<b>SERVICE BULLETIN</b>	
	<b>Flight Design GmbH</b> Sielminger Str. 51 D-70771 L.-Echterdingen Tel +49 (0)711 90287-0 Fax +49 (0)711 90287-99 E-Mail: <a href="mailto:airworthiness@flightdesign.com">airworthiness@flightdesign.com</a>	<b>SB-SECS-CTSW-05</b> <b>Revision 00</b>
		Date of Initial Publication: <b>30-Nov-2009</b> Publication Date of this Revision: <b>30-Nov-2009</b>

## Stabilizer Rear Wall Stiffening SB-SECS-CTSW-05

#### 4.2 Pictures

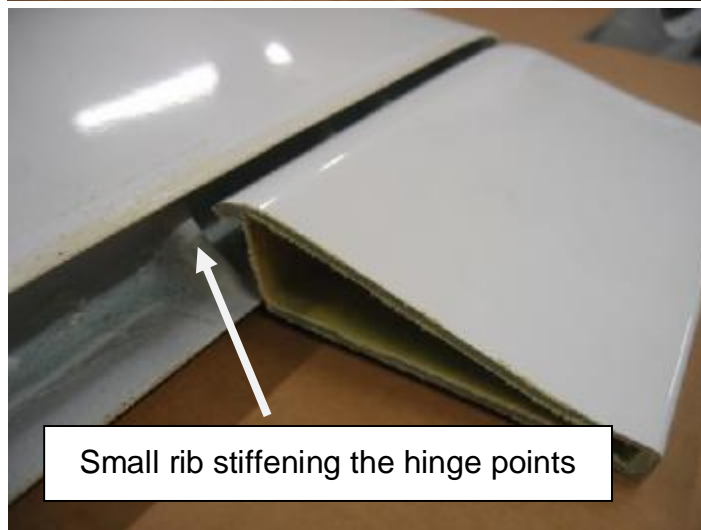
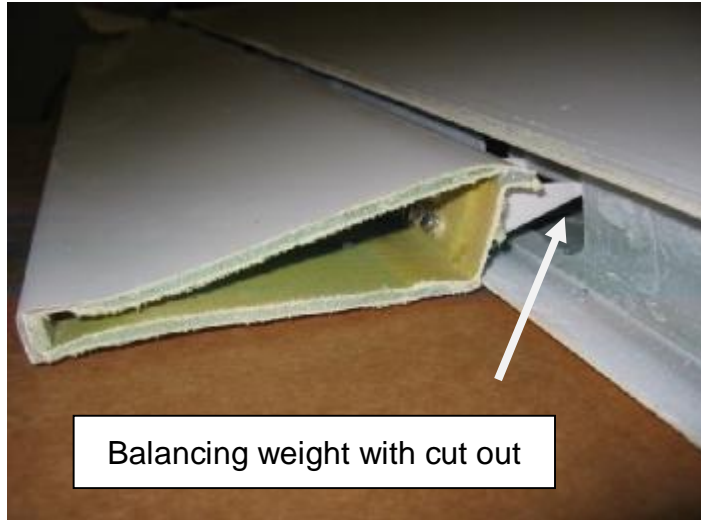
Stiffening of the rear wall of the stabilizer by installation of ribs in the cut-outs for the balancing weights, and direct support of the individual hinge points with small ribs.

Pictures in the Appendix of this SB illustrate balancing weights with cut outs and the small ribs, which supports each hinge point.
